- 17/04673/OUT

**Land At Junction With Carr Road Hollin Busk Lane
Sheffield S36 1GH**

Outline application for up to 93 residential dwellings including open space **(Revised D&A Statement)**

Plan 4:

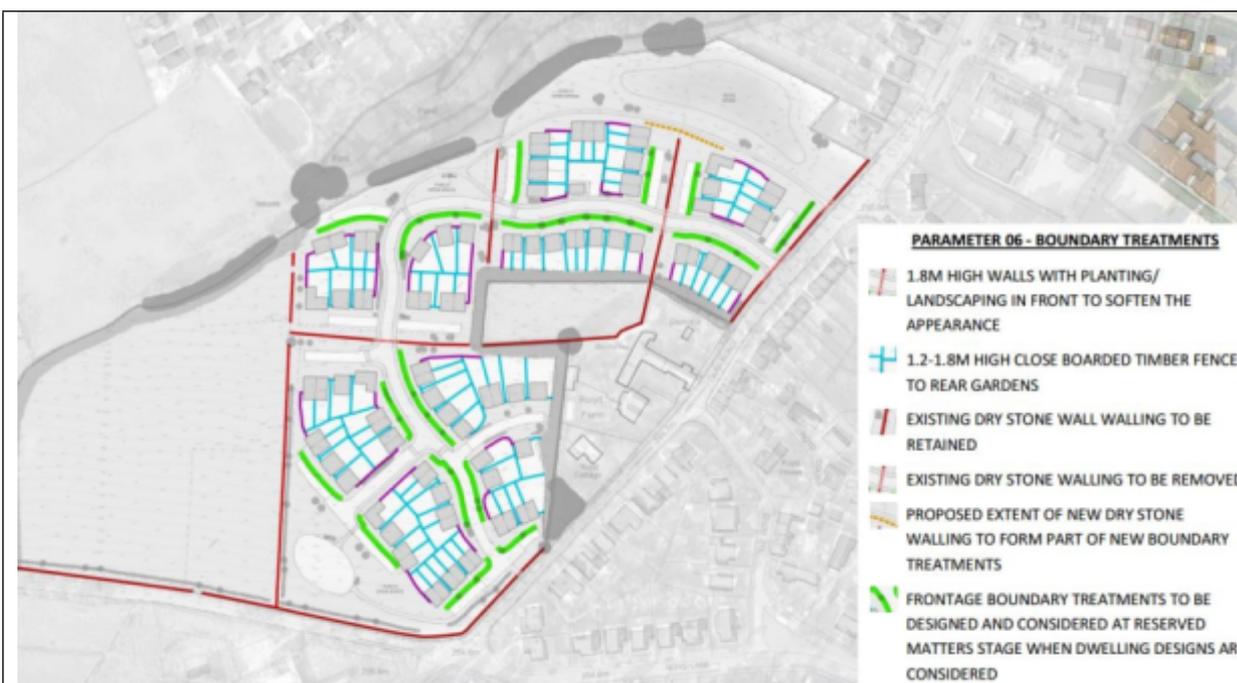
This plan does not say anything about where the densities can be higher and where they can be lower within the overall 35 DPH such that the overall massing will respond to the setting and character.

I would suggest that visually the densities could be higher facing the primary spine and Carr Road, and lower abutting the green countryside setting.

Plan 6:

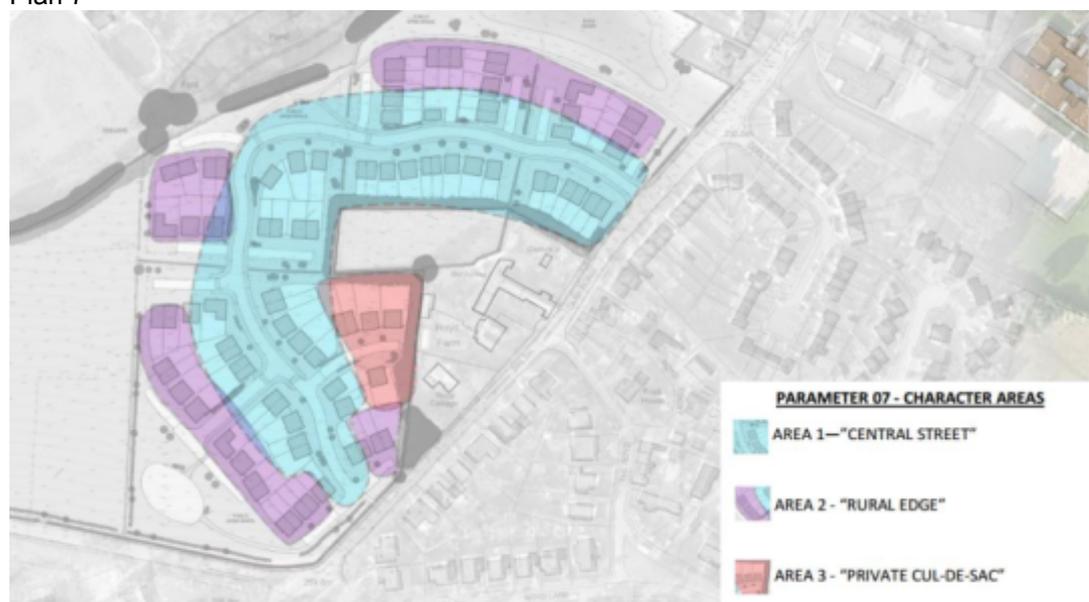
Front boundary treatments should include a hedge, wall or a combination of wall and railings as a minimum with the precise detail to be considered at the next stage. It is important to establish the principle of a strong front boundary now rather than leave it completely open as proposed..
